Vermont Agency of Transportation
RECEIVED
 CK'D BY NA/AG OK'D BY JS
 March 24, 2015
 RESUBMIT YES Rejected
 BY KH DATE 3-30-2015

I-91 NB LEFT LANE CLOSURE (BARRELS)

PROJECT NAME: HARTFORD	FILE NAME: sl2a026_NB Left Closure.dgn	PLOT DATE: 03/24/15
PROJECT NUMBER: IM 091-2(79)	PROJECT LEADER: K. HIGGINS	DRAWN BY: B. LYON
	DESIGNED BY: B. LYON	CHECKED BY: S. SAWYER
	I-91NB LEFT LANE CLOSURE (BARRELS)	SHEET 32 OF ??

CONCEPT - NEEDS MORE WORK

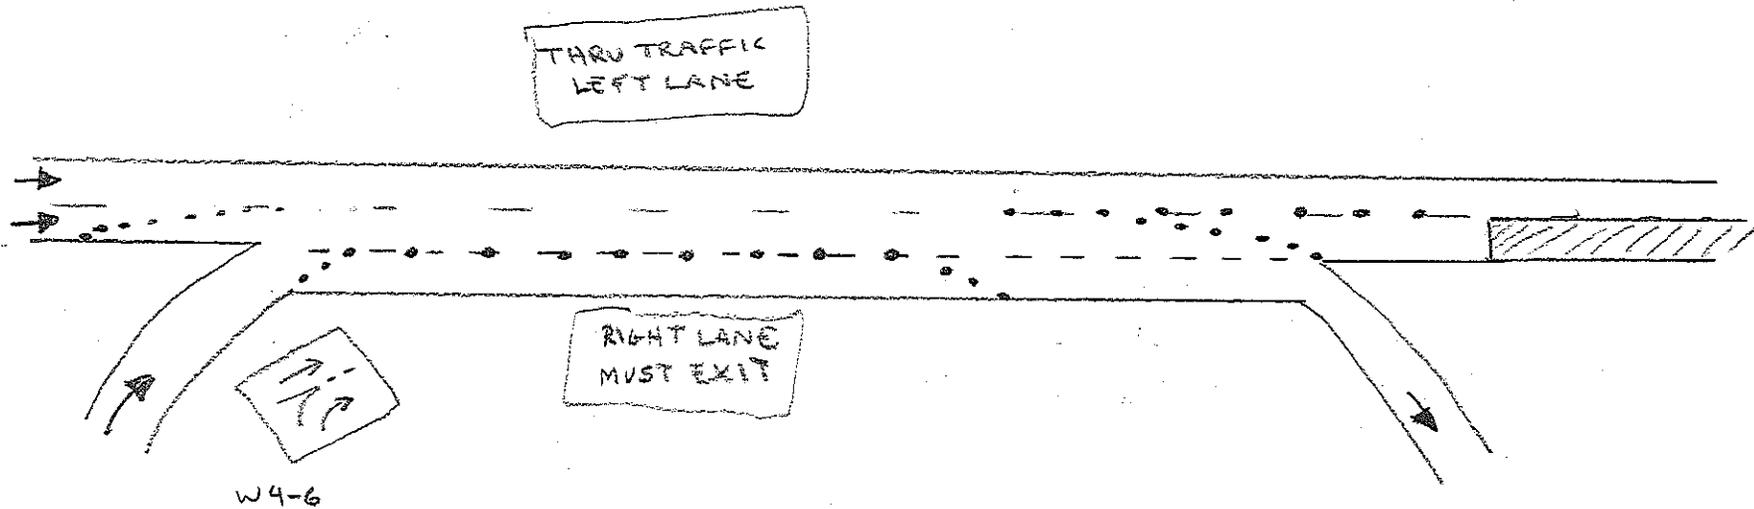
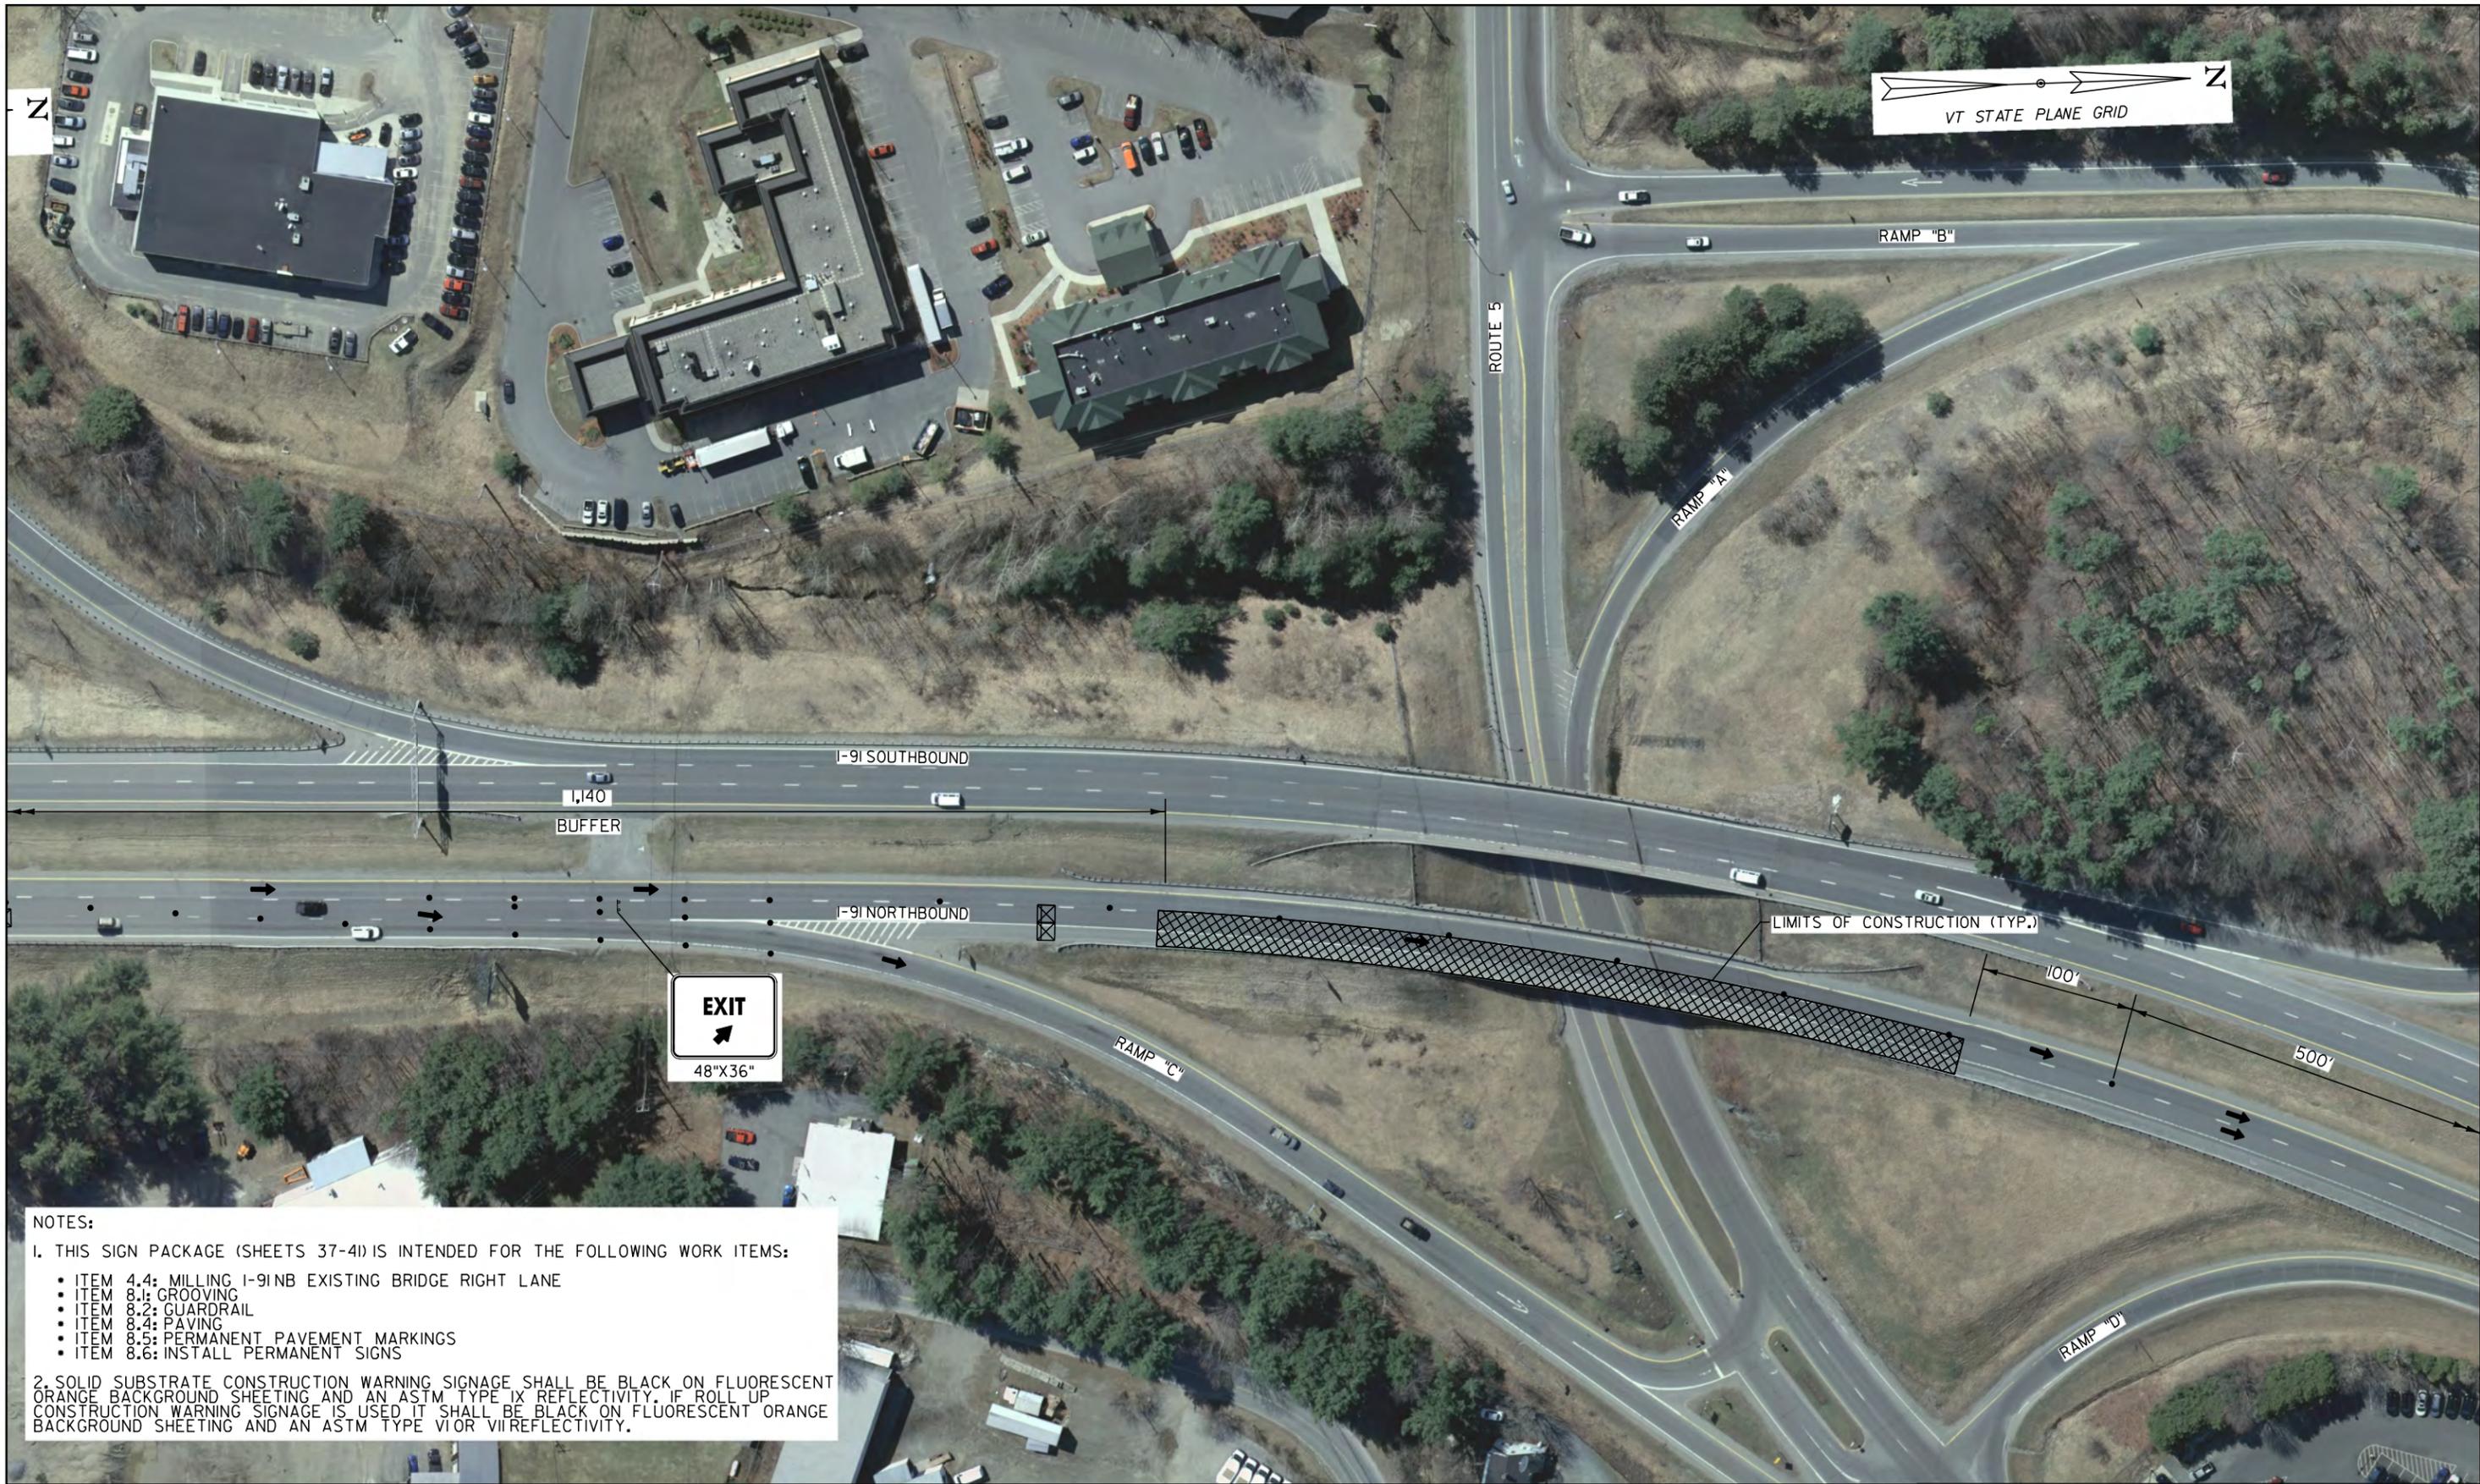
This puts all 91 NB traffic into left lane as shown on sheet 39, but keeps right lane open for I-89 ramp traffic

PROJECT NAME: HARTFORD	PLOT DATE: 03/24/15
PROJECT NUMBER: IM 091-2(79)	DRAWN BY: B. LYON
FILE NAME: sl2a026_SB Right Closure.dgn	CHECKED BY: S. SAWYER
PROJECT LEADER: K. HIGGINS	SHEET 55 OF ??
DESIGNED BY: B. LYON	
I-91 SB RIGHT LANE CLOSURE (BARRELS)

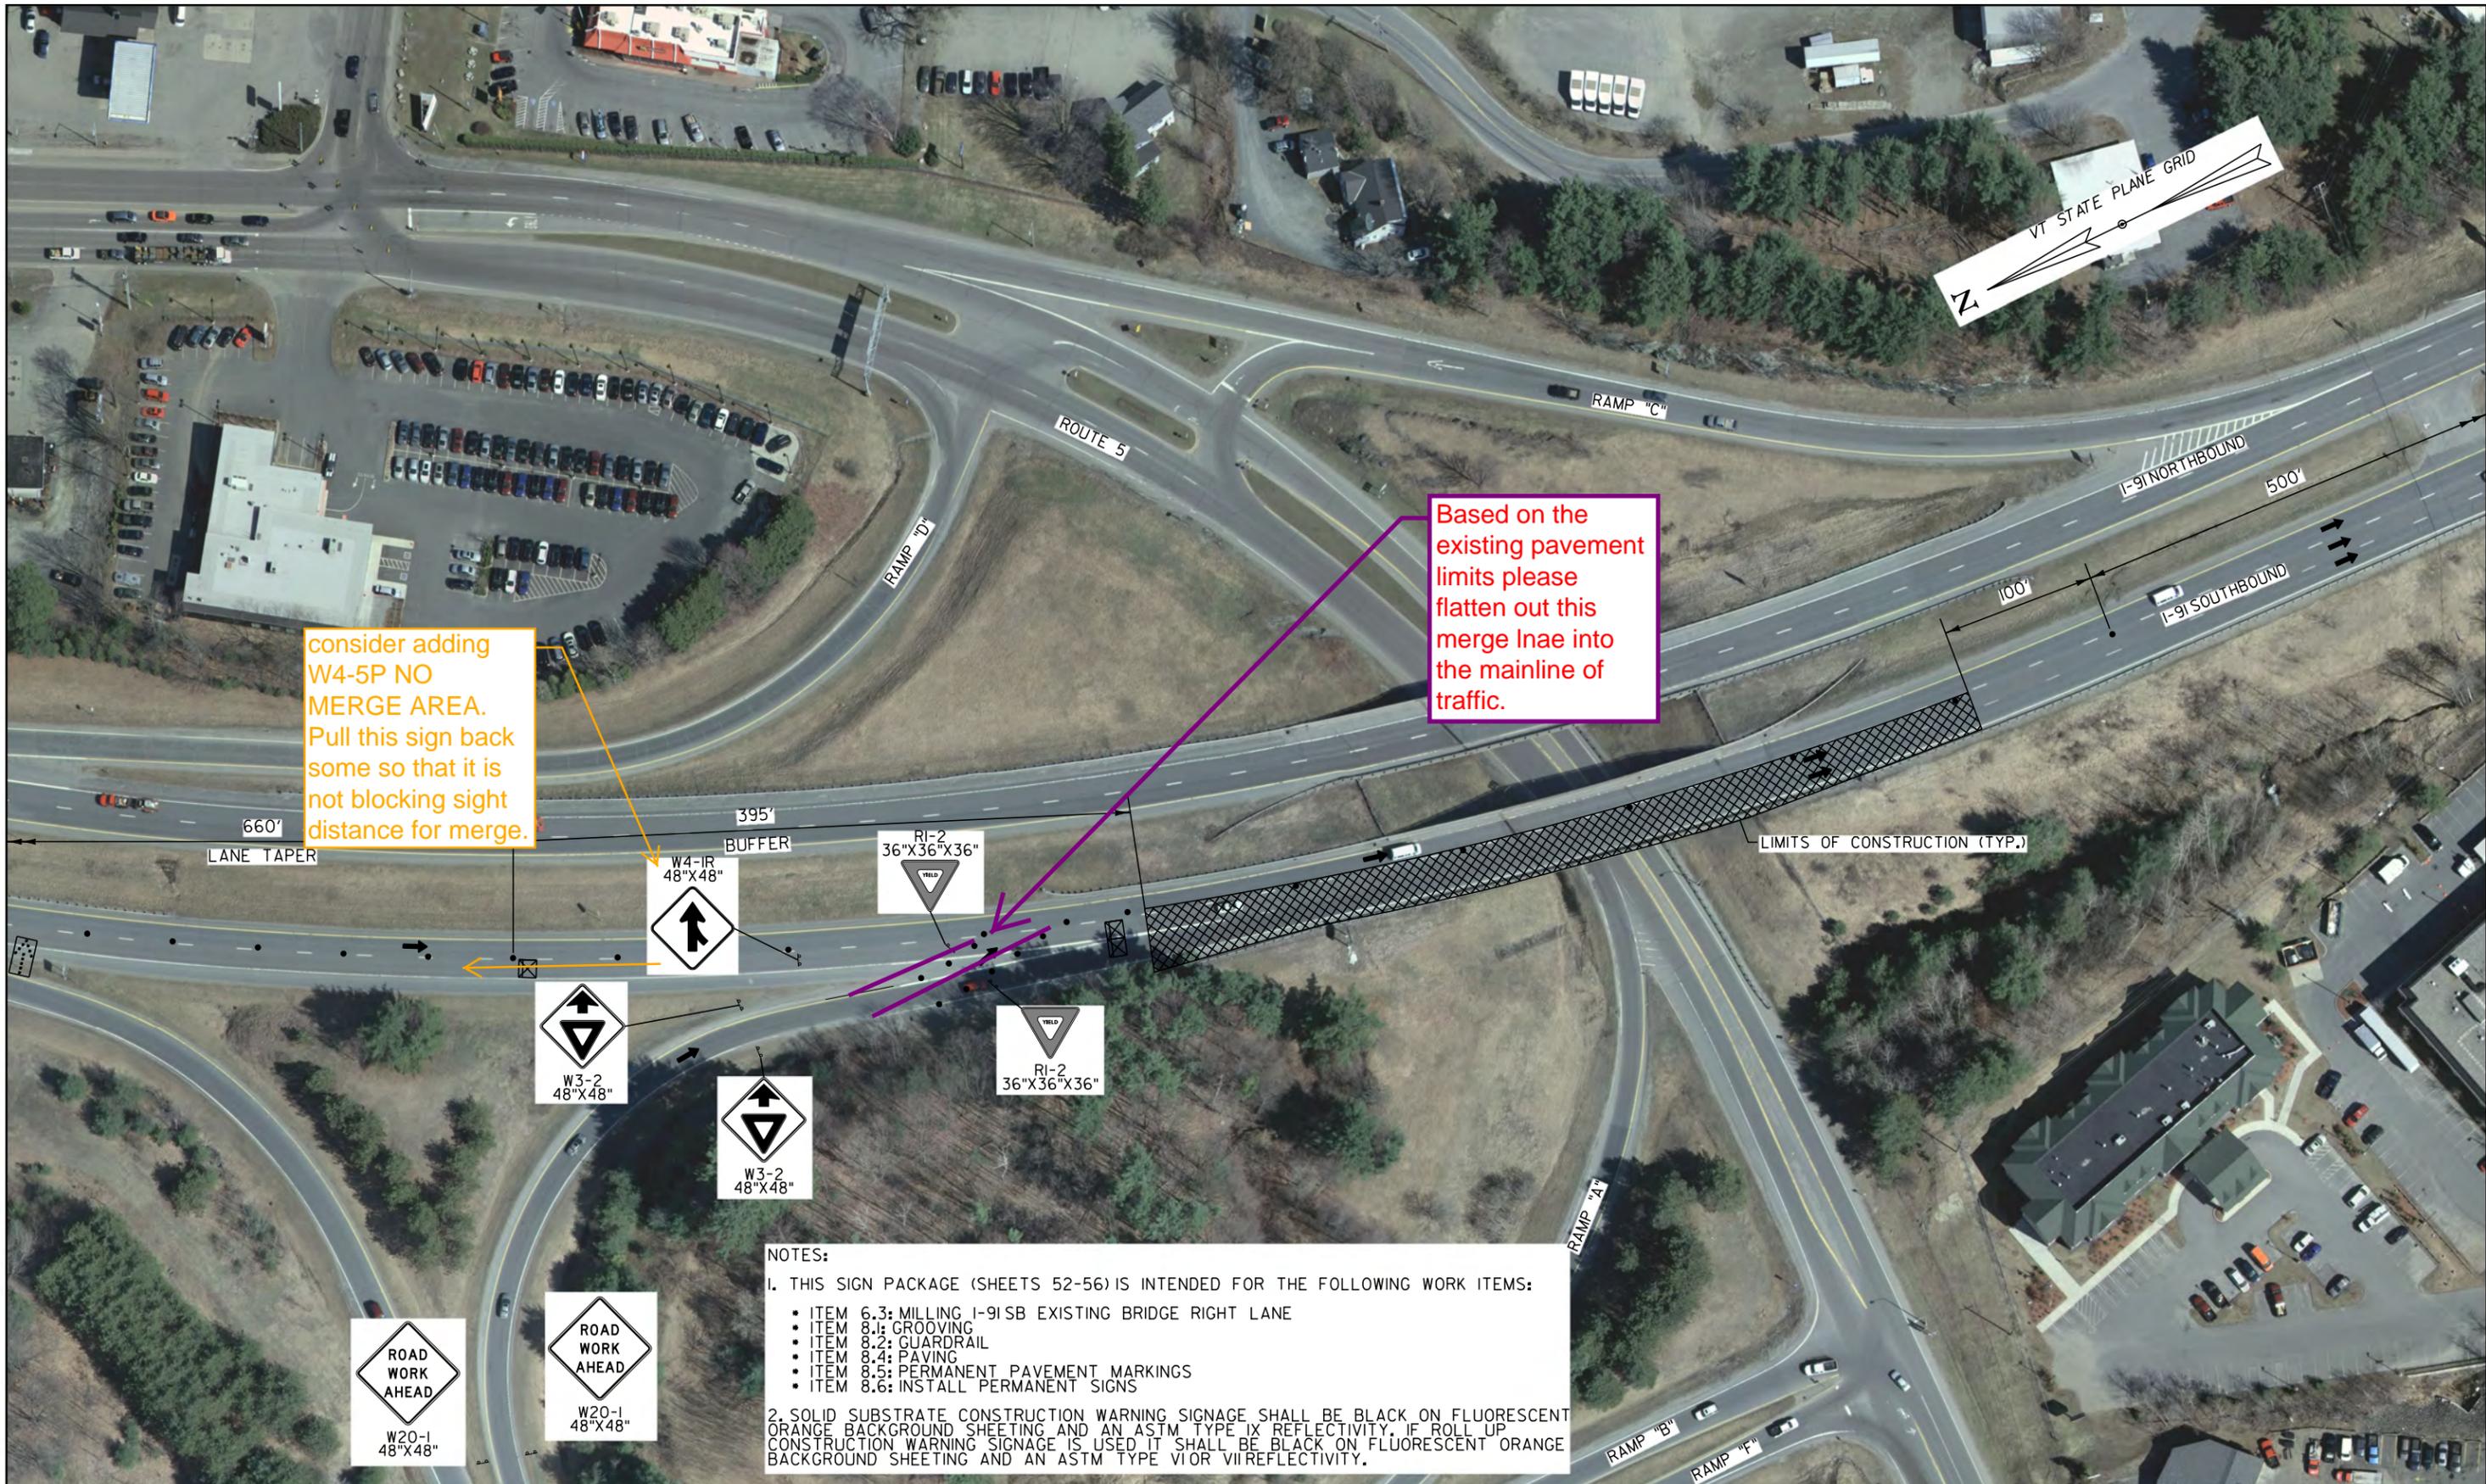
consider adding W4-5P NO MERGE AREA. Pull this sign back some so that it is not blocking sight distance for merge.

Based on the existing pavement limits please flatten out this merge lane into the mainline of traffic.
